12th December, 2019

RE: Sydney Gateway Road Project

Figure ES.2 Community feedback about the project

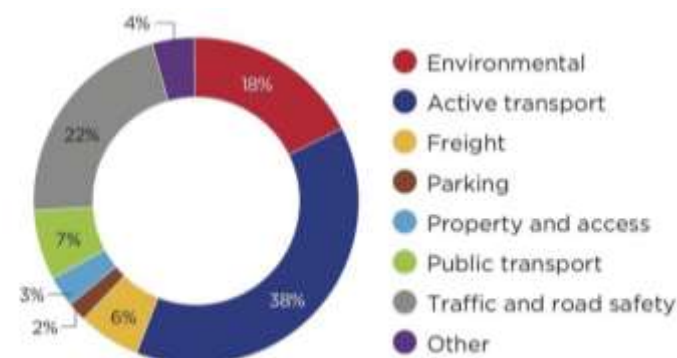
We remain concerned that so little of the plans, assessments and studies were devoted to cycling and active transport and the opportunities it offers to improve health, livability, community amenity and congestion. 38% of stakeholder concern raised during consultation related to active transport, so this is obviously a priority.

On this basis, as well as in light of the stated intention of the project to reduce congestion, incorporate sustainability principles and improve safety, we recommend enhancing walking and cycling connections.

Figure 4-8 Existing and proposed cycle routes within the study area

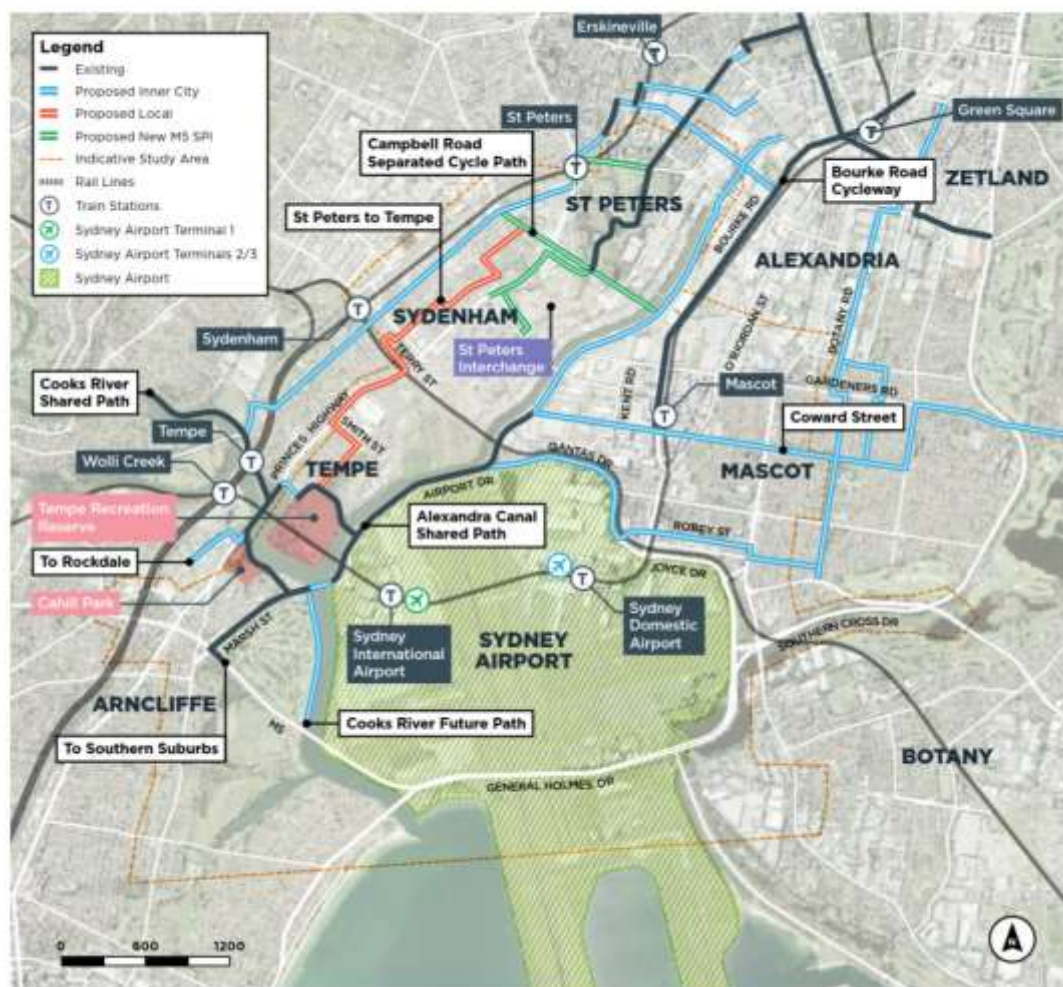
Delivering the walking and cycling connections within the study area and adding the enhancements we have recommended will help ‘future-proof’ this project from anticipated population increases and 60,000 vehicle movements per day¹ by providing people with safe, rideable alternatives and helping to reduce road congestion. Transport for NSW has positive provisioning as a core principle, and this project needs to deliver for people walking and cycling, not just for motor vehicles.

Current measurement indicates that the Alexandra Canal carries around 600 cyclists per day and 100 pedestrians per day however demand is currently suppressed due to a scarcity of safe cycling connections to this route, the Domestic T2 Terminal and around Sydney Airport. This project plans for increased motor vehicle traffic in the area, especially heavy vehicles, which increases the hazard to pedestrians and cyclists if safe, separated alternatives are not provided.

Bicycle NSW recommends the development of separated facilities for walking and cycling to accommodate increased demand and, where this is not possible, that shared paths be built at least 5 meters wide. This conforms with the Austroads Guide to Road Design.
